ADDENDUM No. 05

Date MARCH 13, 2013

Project Name SHAW LANE LIME RESIDUAL DISPOSAL FACILITY OVERALL SITE PLAN

C.I.P. No. 8702.003

<p>CITY OF AUSTIN DEPARTMENT OF PUBLIC WORKS</p>		<p>TYPE 1 SIDEWALK CURB RAMP</p>	
<p>RECORD COPY SIGNED BY BILL GARDNER</p>	<p>9/14/05 ADOPTED</p>	<p>THE ARCHITECT/ENGINEER ASSUMES RESPONSIBILITY FOR APPROPRIATE USE OF THIS STANDARD.</p>	<p>STANDARD NO. 432S-5</p>

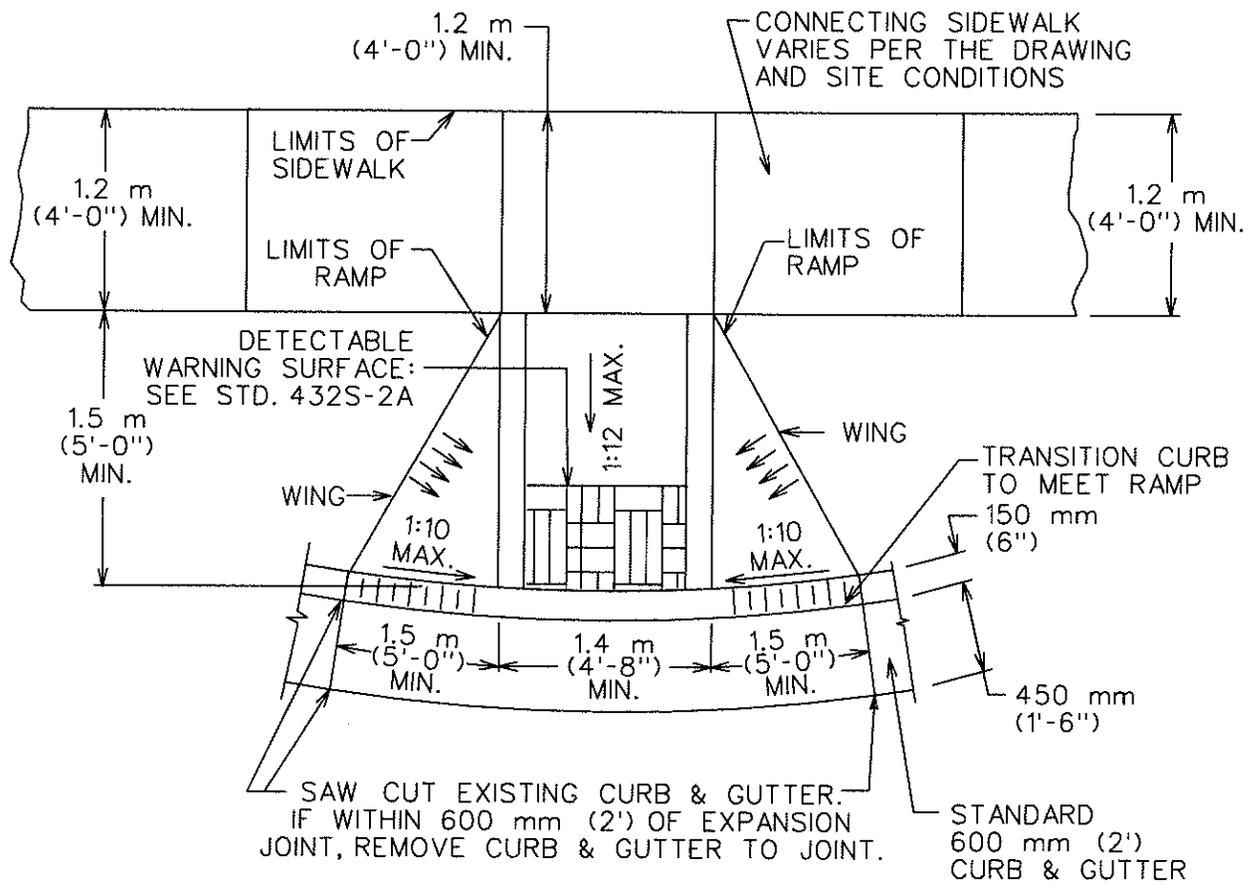
- a. Remove and replace drawings G-002, EX-001, and C-007 with the drawings attached to this addendum.
- b. Attach standard detail 432S-5 to Drawing C-903.
